LIGHT RAIL PERMITTING ADVISORY COMMITTEE MEETING

Subject: September 2, 2015 Advisory Committee Meeting

ADVISORY DOCUMENT - RECOMMENDATION TO THE DIRECTOR - CENTRAL BELLEVUE SEGMENT DESIGN AND MITIGATION PERMIT August 20, 2015

Typical Longspan over I-405

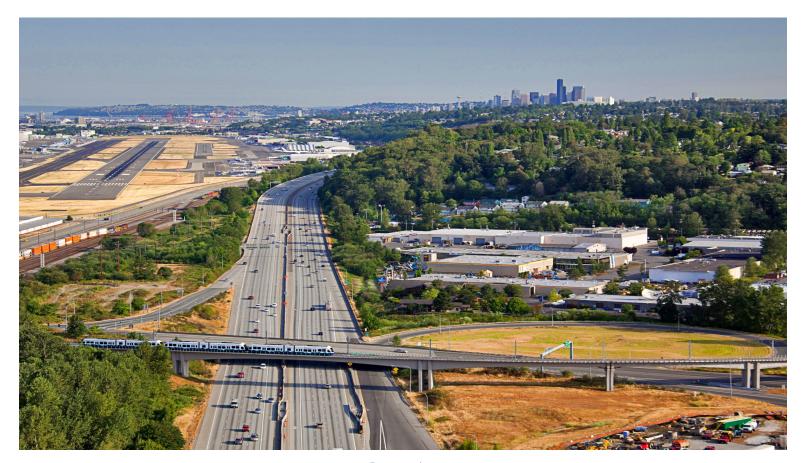
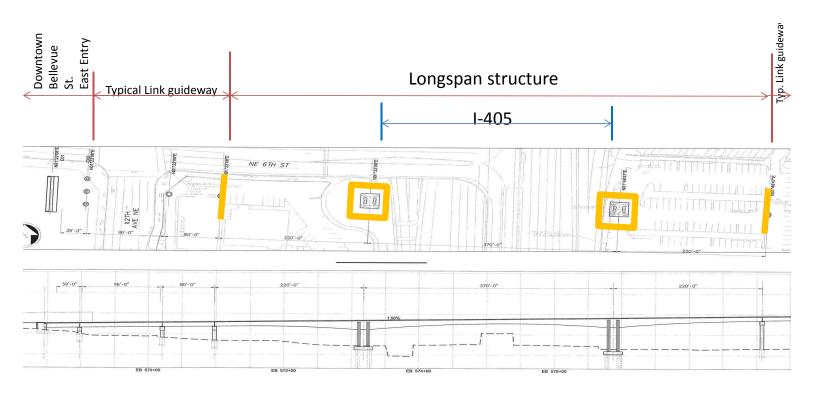
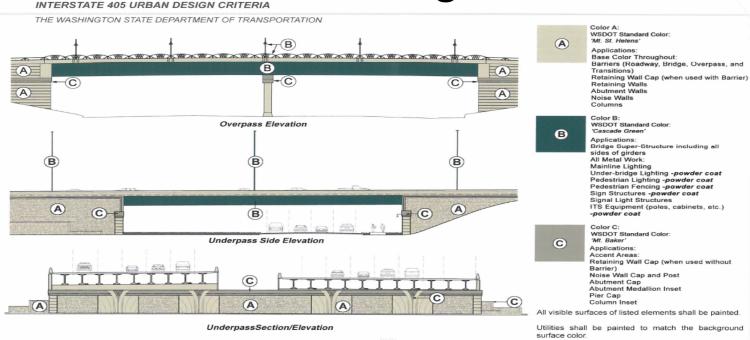
- The CAC recommends a signature treatment of the railing for the entire span from the Downtown Transit Center Station to the Hospital Station. The CAC recommends painting the underside of the elevated guideway green and for Sound Transit to look for opportunities to further enhance the aesthetics of the NE 8th Street crossing south of the Hospital Station.

- The CAC recommends a signature treatment for the railing for the entire span from the Bellevue Downtown Station to the Wilburton (Hospital) Station. The CAC recommends Sound Transit continue to use the style of rail planned for the I-405 crossing to achieve this goal.
